Service Bulletin

Bulletin No.: 21-NA-265

Subject: Coolant Leak Under Truck, Malfunction Indicator Lamp (MIL) Illuminated - DTC P2C48 Set

5924533

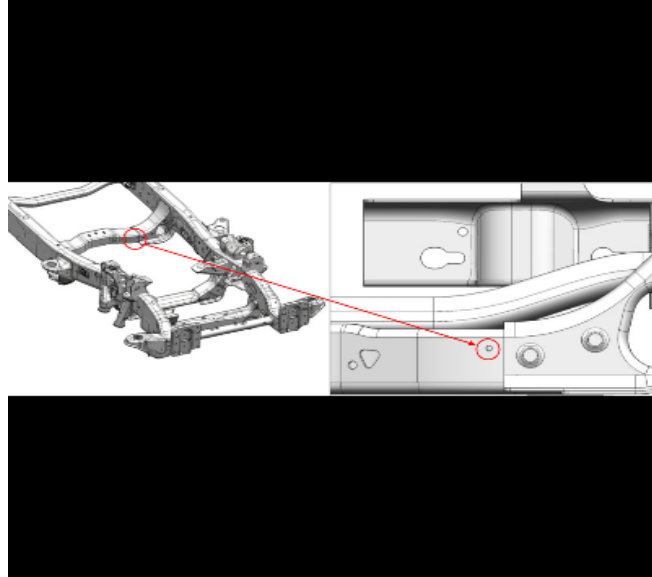
Follow the procedure below to re-route the coolant hose away from the front drive shaft:

1. Utilizing a 6.5 mm drill size, drill a hole in the transmission crossmember in the approximate location noted in the graphic above.

5924534

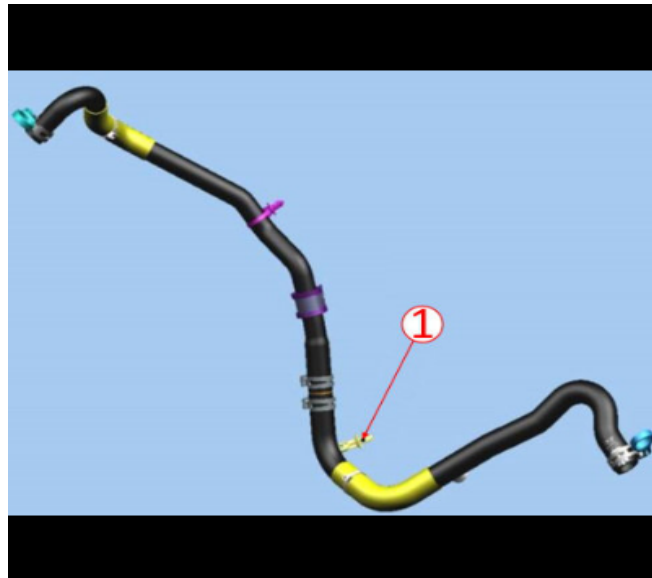
Correction

2. Add retainer or equivalent, onto the hose.
3. Install retainer into the hole in the cross-member.

If the coolant has been found leaking from the hose, replace the hose.
